northern
beaches
council

PRELODGE MENT ADVICE

Application No: PLM2019/0106

Property Address: 4-10 Inman Road CROMER

Extract from Stormwater Map (showing indicative pipe locations):

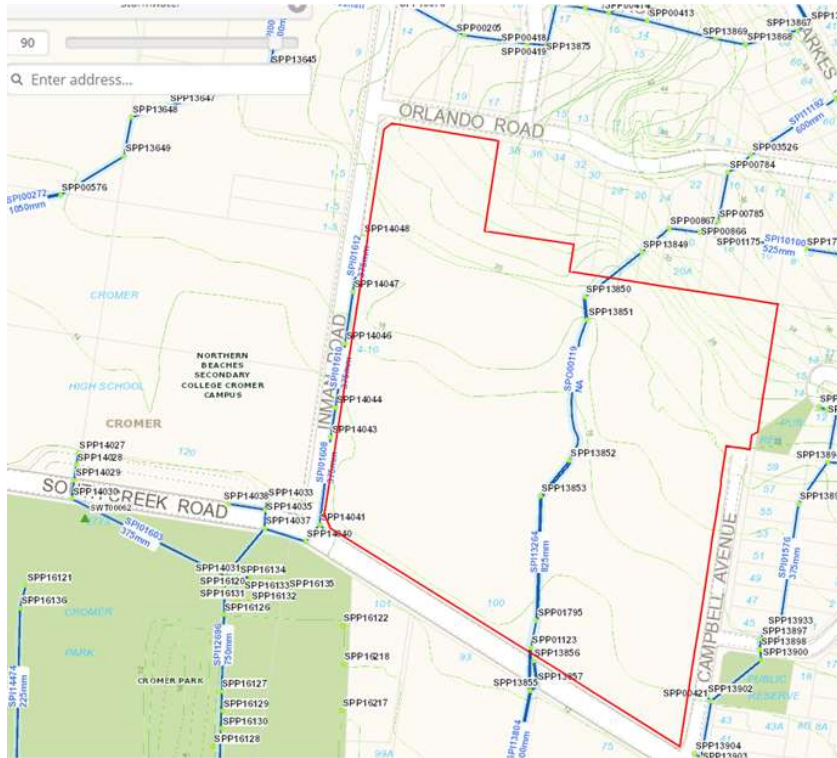
The development site is burdened by a 825mm drainage pipe and an open channel as shown on the Council stormwater map below.

All vertical and horizontal clearances to the existing stormwater assets/ related easements needs to be maintained to satisfy the council requirements.

Any changes to divert existing course of the stormwater drainage paths require prior approval of proposals in consultation with the Council's Stormwater & Flood Plain Engineering section.

- Council's records indicate that 4-10Imnan Road Cromer is burdened by a 825 mm pipe and an open channel drainage path and associated infrastructure. This is shown on Council's stormwater map which is available on the webpage. (Please follow the relevant link below and select the 'Stormwater' map from the 'No Overlay Map' drop down menu. You can then search by address and use the zoom functionality to see pipe diameters and asset id numbers. i.e. 1200mm and SPP or SPI etc).

- Accurately locate, confirm dimensions including depth and plot to scale Council's stormwater pipelines and associated infrastructure on the DA site plans that outline the proposal. This should be carried out by a service locating contractor and registered surveyor. (Evidence of methodology used for locating stormwater system should be provided)

- All structures are to be located clear of any Council pipeline, pit or easement.
 - Footings of any structure adjacent to an easement or pipeline are to be designed in accordance with the above-mentioned Policy.

- Structural details prepared by a suitably qualified Civil Engineer demonstrating compliance with Council's policy are to be submitted.
